# Access Compliance Report

## Public Rights-of-Way

Intersection ID: 26090	Main Street: PROVIDENCE_RD	Cross Street: LAKESIDE_DR	Location: SE
ADA ID: 0C0EAB9AD34B	Ramp Type: Perp	Initial Pass/Fail: Fail	Overall Compliance: No
Severity Score: 8.75			
Codes/Mitigation Info/Possible Solution		Field Measurements/Component Compliance

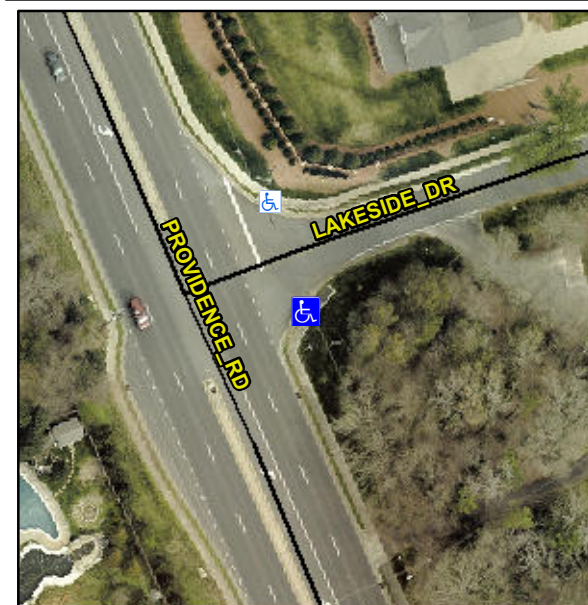
**Not Found, R304.5.1**

Compliance	Description	Data	Compliance	Description	Data
N/A	Ramp Length (in)	73.0	Yes	Ramp Slope (%)	5.6
No	Ramp Width (in)	47.5	Yes	Ramp XSlope (%)	0.3
N/A	Flare Type LT	N/A	N/A	Flare Type RT	N/A
N/A	Flare Slope LT (%)	N/A	N/A	Flare Slope RT (%)	N/A
N/A	Flare Traversable LT?	N/A	N/A	Flare Traversable RT?	N/A
N/A	Landing Length (in)	N/A	N/A	DWS Provided?	N/A
N/A	Landing Width (in)	N/A	N/A	DWS Contrast?	N/A
N/A	Landing Slope (%)	N/A	N/A	DWS Length (in)	N/A
N/A	Landing X Slope (%)	N/A	N/A	DWS Full Width?	N/A
N/A	Landing Curb? (Y/N)	N/A	N/A	DWS Offset (in)	N/A
N/A	Shared Landing?	N/A			
N/A	Gutter Ponding?	N/A	N/A	Gutter Slope (%)	N/A
N/A	Gutter Lip Ht (in)	N/A	N/A	Gutter X Slope (%)	N/A
N/A	Painted X Walk1?	No	N/A	Painted X Walk2?	N/A
	X Walk 1 Direction	To N		X Walk 2 Direction	N/A
N/A	X Walk 1 Width (in)	N/A	N/A	X Walk 2 Width (in)	N/A
	X Walk 1 Slope (%)	3.0		X Walk 2 Slope (%)	N/A
	X Walk 1 X Slope (%)	0.8		X Walk 2 X Slope (%)	N/A

**Remove & Replace Entire Ramp.**
